## Application for Licence Amendment

<b>Licence Number</b>	L8676/2012/1
<b>Licence Holder</b>	AngloGold Ashanti Australia Limited
<b>ACN</b>	008 737 424
<b>File Number</b>	2012/002666-3
<b>Premises</b>	Tropicana Gold Mine Part of mining tenement M39/1096 PLUMRIDGE LAKES WA 6431 As defined by the coordinates in Schedule 1 of the licence
<b>Date of Report</b>	17 July 2020
<b>Proposed Decision</b>	Revised licence granted

**Figure 1: Proposed waste landform expansion to impact existing monitoring bore TSFMB009S/D**

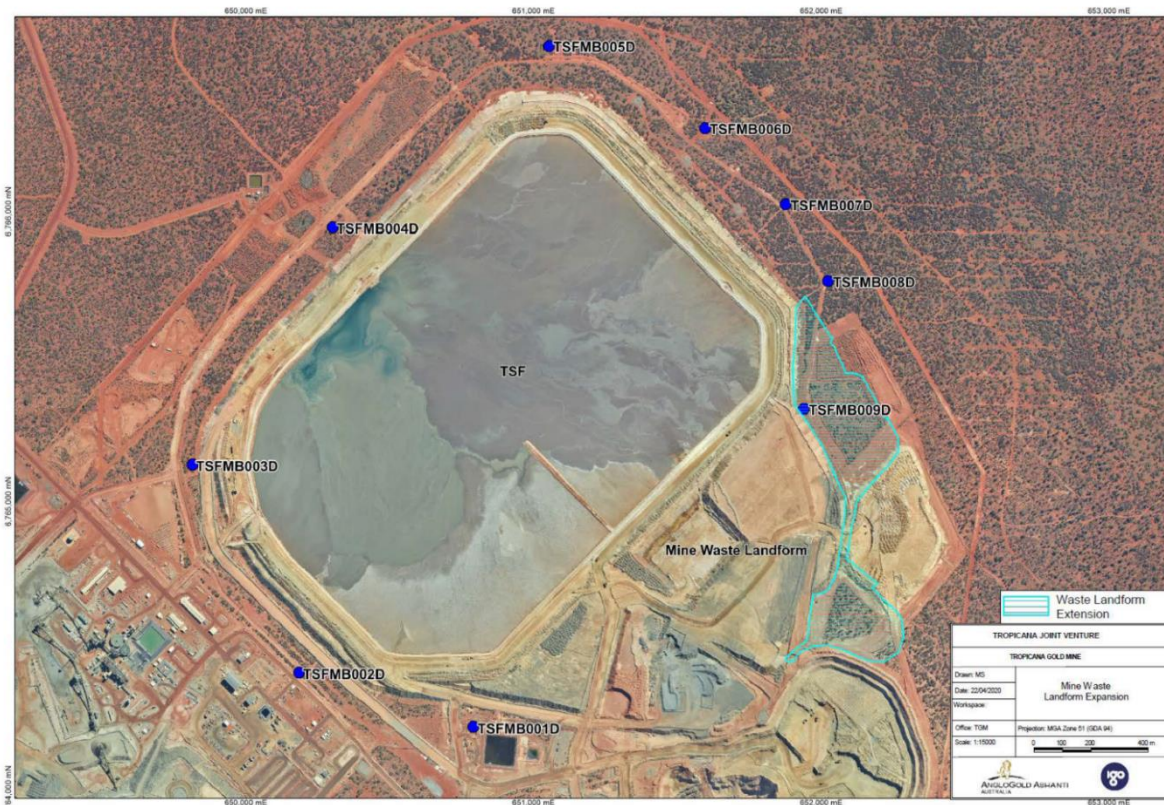
However, the waste rock storage will result in the decommissioning of three pairs of groundwater monitoring bores (six bores in total), which are listed as compliance monitoring bores in Table 3.2.1 of Licence L8676/2012/1. These are listed in Table 1. The purpose of

Figure 1 shows the proposed expansion area that will impact existing monitoring bore TSFMB009S/D, while Figure 2 shows the buttressing that will impact TSFMB003S/D and TSFMB004S/D. Figure 3 shows the remaining and proposed new monitoring bore locations. The new bores are circled in green. The Delegated Officer considers that these are acceptable alternate seepage monitoring locations.

Each pair of removed monitoring bores will be replaced with an equivalent paired set of deep and shallow monitoring bores in down-hydraulic gradient of the existing locations and within similar geologies. The locations will be outside the anticipated waste landform footprint. There is some native vegetation located between the TSF and proposed bores that could be receptors in the event of groundwater mounding. However these areas are already impacted by mining activities, and mostly located within the rock storage footprint for which clearing approval has been obtained. Hence it is anticipated that the intent of each monitoring location in monitoring impacts to vegetation will be preserved.

The decommissioned bores will be capped to prevent contamination of aquifers from waste rock or leachate entering the decommissioned bores.

**Figure 3: Proposed Ambient Groundwater Monitoring Locations – new bores circled**

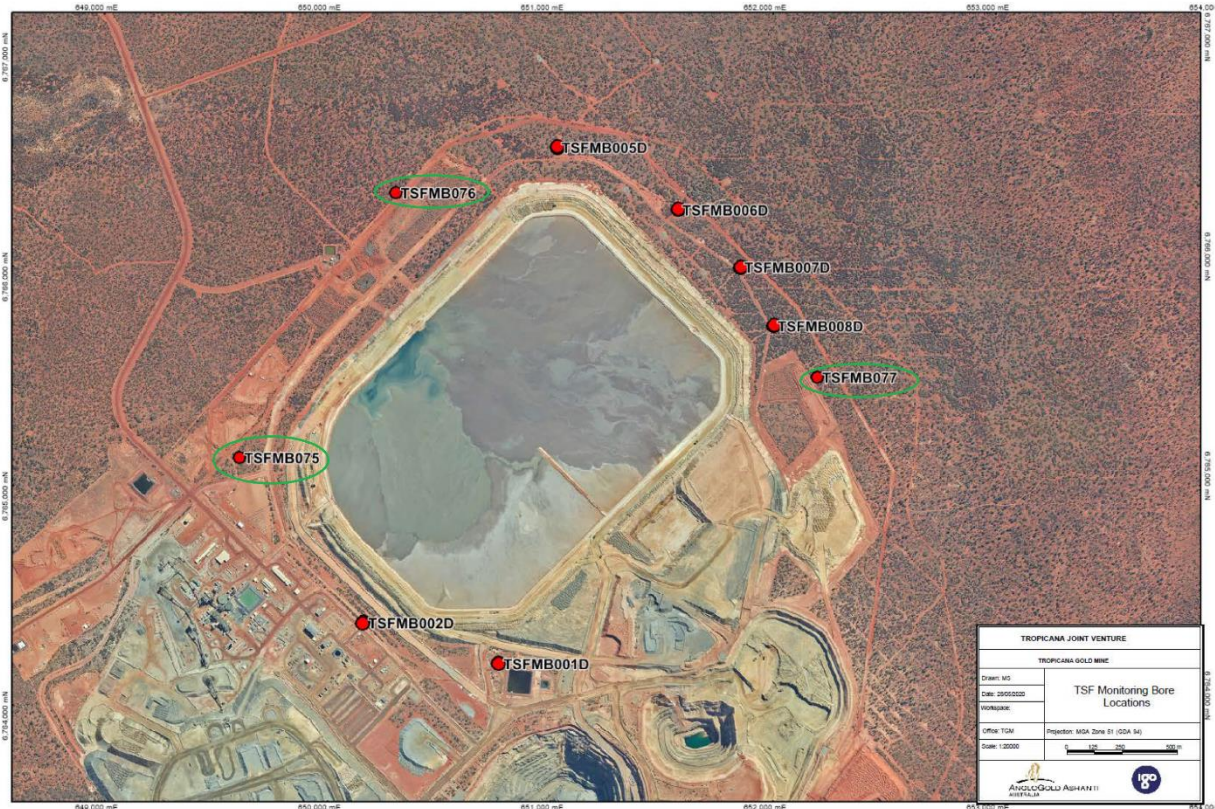
Existing Monitoring Bore Pair (Remove from Licence)	Proposed Monitoring Bore Pair (Add to Licence)	Approximate Location Relative to Original Bores
TSFMB003S and TSFMB003D	TSFMB075S and TSFMB075D	250 m west
TSFMB004S and TSFMB004D	TSFMB076S and TSFMB076D	430 m north
TSFMB009S and TSFMB009D	TSFMB077S and TSFMB077D	330 m east-north-east

**Figure 5: Condition 4.2.3 in the existing licence**

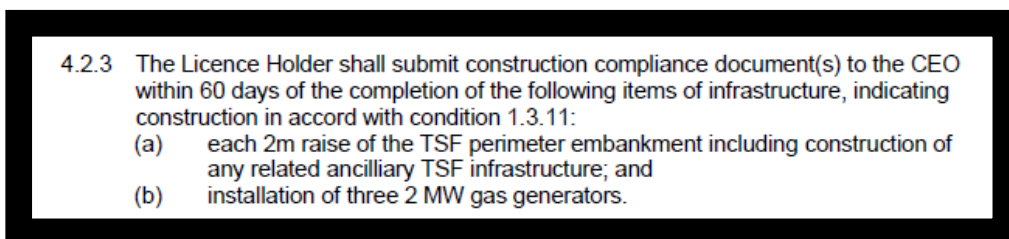
Condition 4.2.3 (reproduced in Figure 5 below) relates to the timeframes for submission of

On 11 March 2020, the licence holder submitted the compliance documents for three, 2m raises to 354, 356 and 358m RL. DWER noted that based on the construction schedule provided in the report, submission was not within 60 days of the completion of the earlier lifts. This was a technical non-compliance with condition 4.2.3 as the three lifts were constructed sequentially as three sub-lifts in a 6m raise project, and documents submitted only after completion of the third lift. There is no potential or actual environmental impact associated with this non-compliance. In this amendment application, the Licence Holder requested a change to the wording of condition 4.2.3 to allow submission for their next 6m raise project (comprising three, 2m lifts) at the end of the project.

The Delegated Officer considers that until compliance documents are received, the crest of the TSF is deemed to be the crest height of the previously constructed lift (for which compliance documents have been submitted). Therefore in accordance with condition 1.3.9, tailings or liquor must not come within 300mm of the top of the previously constructed crest until the compliance documents for the newly constructed lifts are submitted. This was identified as a risk to the Licence Holder of delaying submission until after completion of the 6m raise project. However the Licence Holder stated that raises are completed well ahead of tailings deposition, so the required freeboard can be maintained below the previously constructed lift. Therefore the Delegated Officer considers there is no change in environmental risk in requiring construction compliance documents after each 6m raise, rather than every 2m increment which is operationally impractical.

- Condition 1.3.11 – change ‘Each raise height 2m’ to ‘each sub-raise height 2m, completed in batches of 3 sub-raises totalling 6m’
- Condition 4.2.3 – change ‘each 2m raise’ to ‘each 6m raise’
